Dale La Forest & Associates
Design, Planning & Environmental Consulting
101 E. Alma Street, Suite 100-A; Mt. Shasta, CA 96067
Phone: (530) 918-8625 E-Mail: dlaforest@gmail.com

Report of Potential Noise Impacts of Hyatt House Hotel Project

Master Plan Approvals at 1550 North San Pablo Street;
Hyatt House Hotel MPA (DCP Case Nos. ZA-2020-1128-MPA; ENV-2020-1129-CE);
USC Conference Center MPA (DCP Case Nos. ZA-2020-1097-MPA, ENV-2020-1091-CE)

Figure A – Proximity of Hotel's Outdoor Activity Areas to Adjacent Graduate Student Housing Apartments

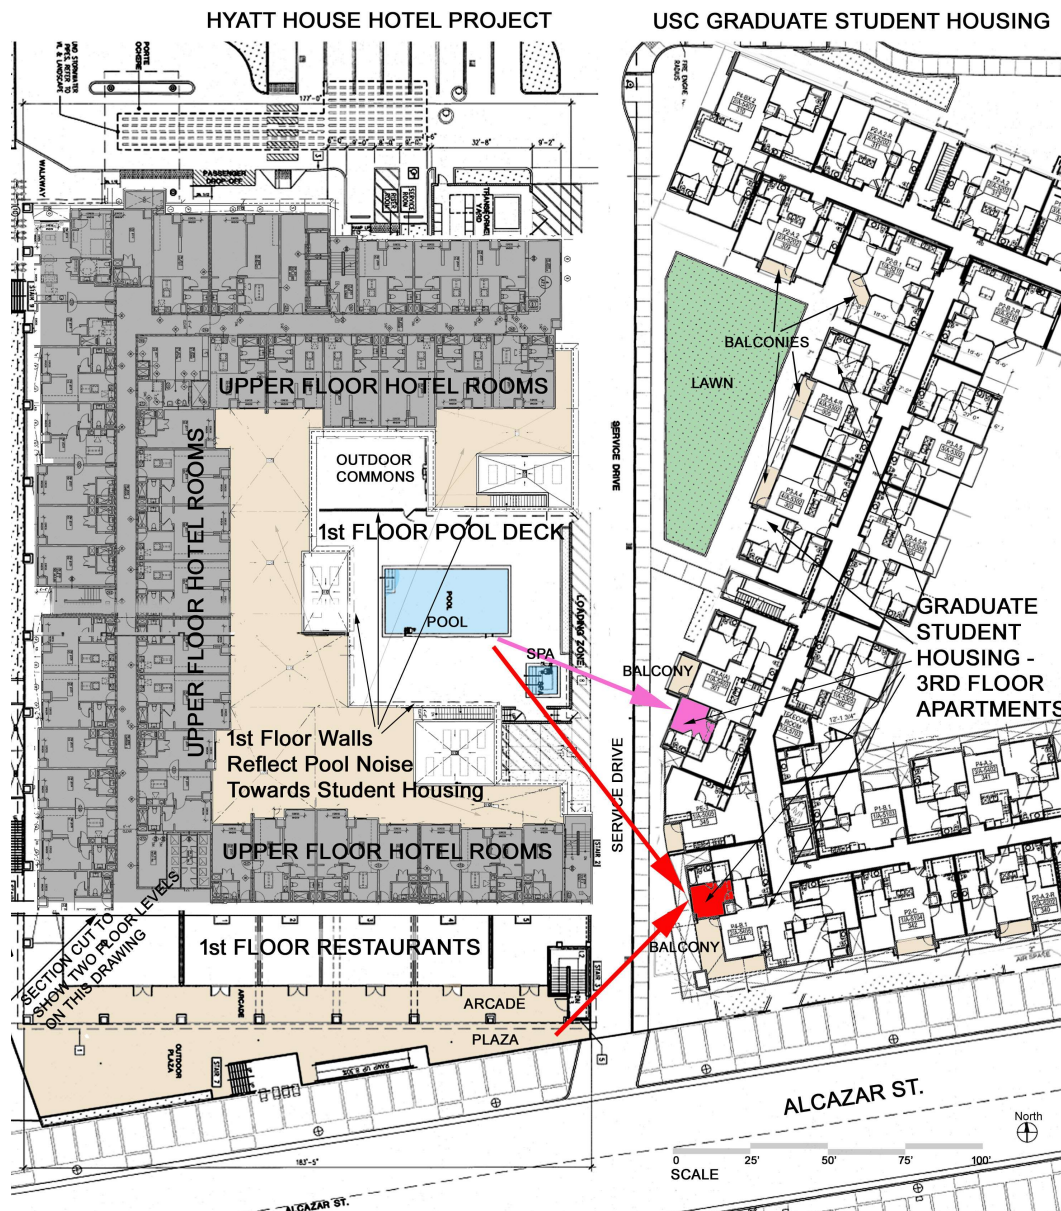
The adjacent “outdoor commons area” is about 990 SF in area and has been illustrated with 22 seats occupying about half the space.¹ In the other 495 SF without seats in this commons area, as many as 70 people could stand at the 7 SF per standing guest per the Cal. Bldg. Code. The “outdoor commons area” could therefore have about 92 guests at one time. (70 + 22 = 92 people.) In total, as many as about 322 people could occupy these two outdoor areas at one time. (230 + 92 = 322.)

A scientific report⁹ measured as typical a person's very loud speech at 78 dBA at 1 meter (3.3 feet). Then at a distance of 25 feet, that noise level can be calculated to be reduced by distance to about **60.4 dBA**.¹⁰ However, if 80 people are speaking simultaneously at the same volume, their combined voice levels would be about **79.4 dBA at a distance of 25 feet**.¹¹ Or at 50 feet away from the center of that medium size crowd, their combined vocal noise levels would be about **73.4 dBA**. 50 feet is the distance from the center of the pool area to the property line adjacent to the graduate student housing building where one of the Project's conditions of approval prohibits this noise from being *audible*. These noise levels would be clearly audible there. And at 75 feet, the calculated noise level from the center of such a crowded outdoor pool deck area could be about **69.9 dBA**. 75 feet is the distance from the center of this pool deck area to the nearest graduate student housing building to the east.¹² (See **Figure A**.)
